Request for Proposal, 17MCO528
In response refer to RFP No. 17MCO528 Addendum 1 (one)
December 18, 2017

Please note that there has been a change made to the original request for proposal. The following information shall be added to **PAGE 9** as follows:

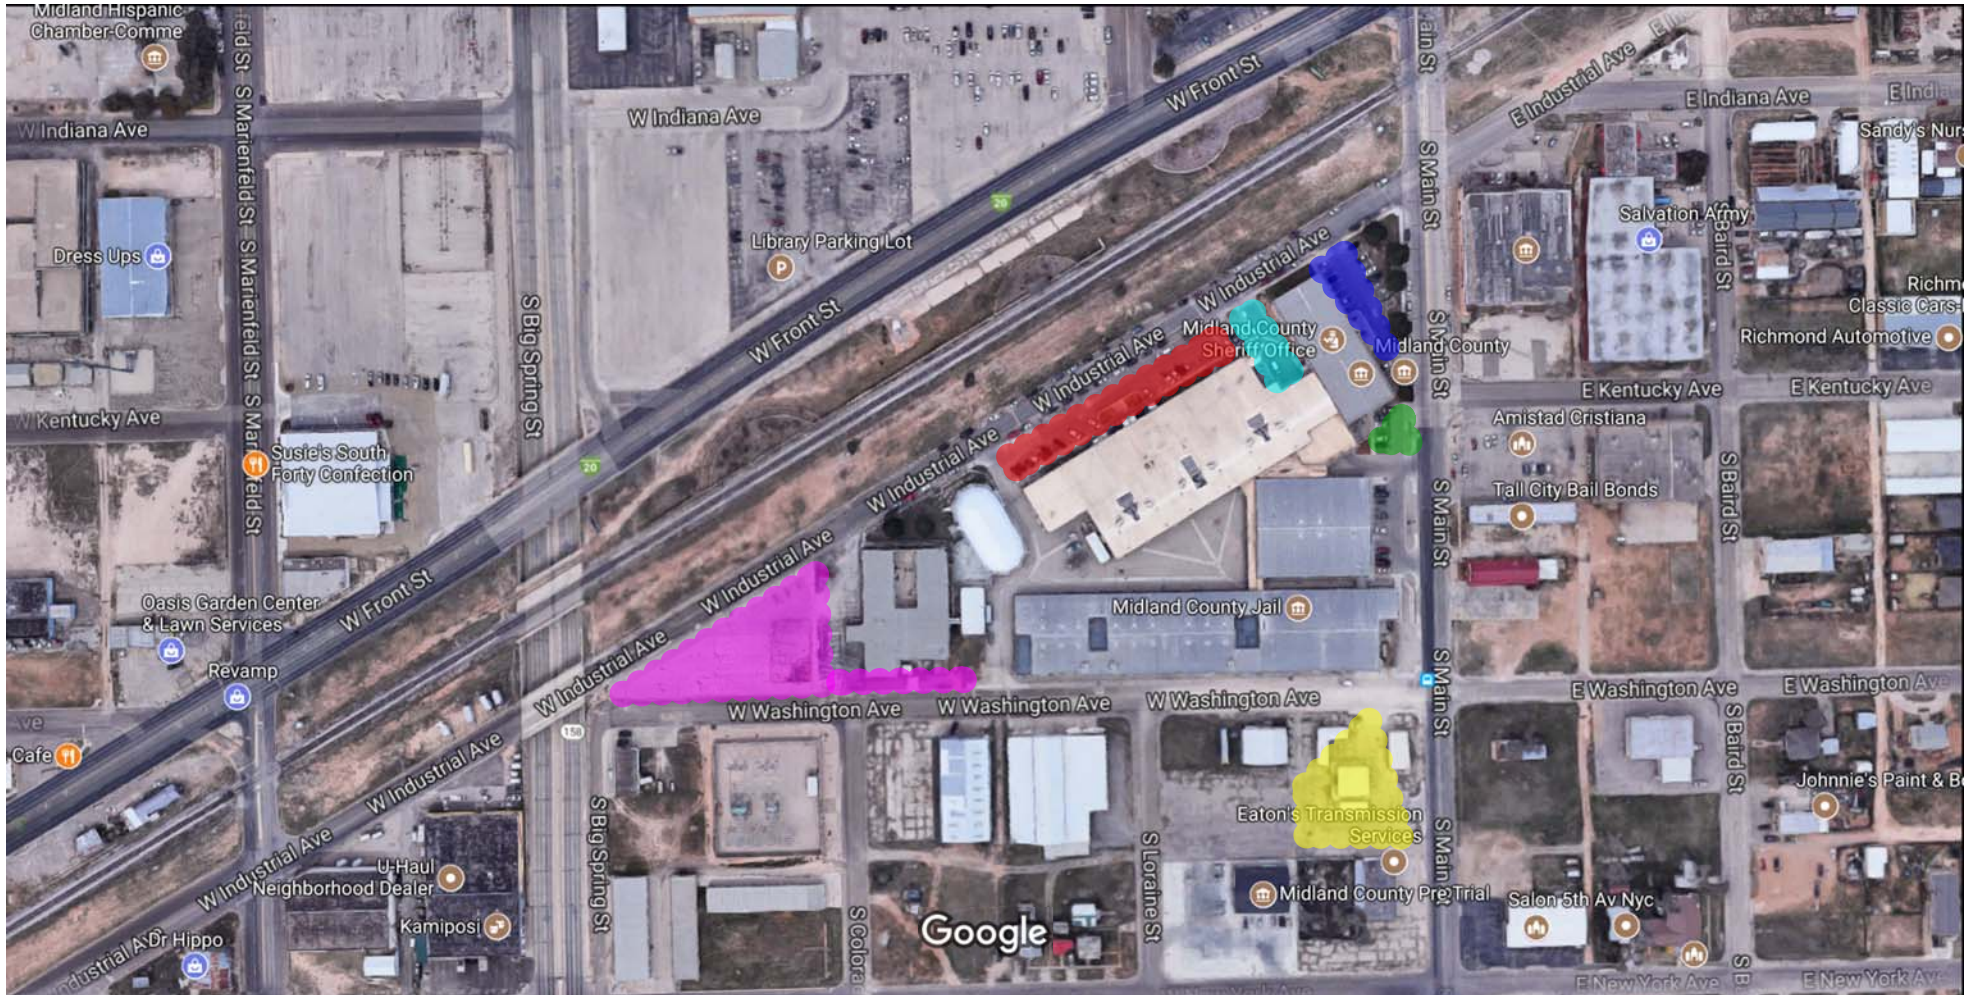
The map of the six (6) parking lots are shown in ATTACHMENT A. [A revised map of the six \(6\) parking lots are shown in ATTACHMENT B.](#) Vendor will be responsible for providing all supplies, equipment and labor to re-pave these lots with an asphalt paving. This project is to include removal of current pavement and hauling away all debris. Vendor is responsible for all permitting and for meeting City of Midland codes regarding paving of parking lots. Vendor will also be responsible for re-stripping the parking spaces.

[The following ROUGH measurements were taken. Please note that these are not completely accurate measurements and it is advised that the vendor measure the areas themselves.](#)

[LOT A – 64’ W x 171’ L = 10,944 sq ft.](#)

[LOT B – 39’ W x 65’ L = 2,535 sq ft.](#)

[LOT C – 148’ W x 336’ L = 49,728 sq ft.](#)

[LOT D – 62’ W x 366’ L = 22,692 sq ft.](#)

[LOT E – 197’ W x 327’ L = 64,419 sq ft.](#)

[PAINTER DRIVE – 28’ W x 111’ L = 3,108 sq ft.](#)
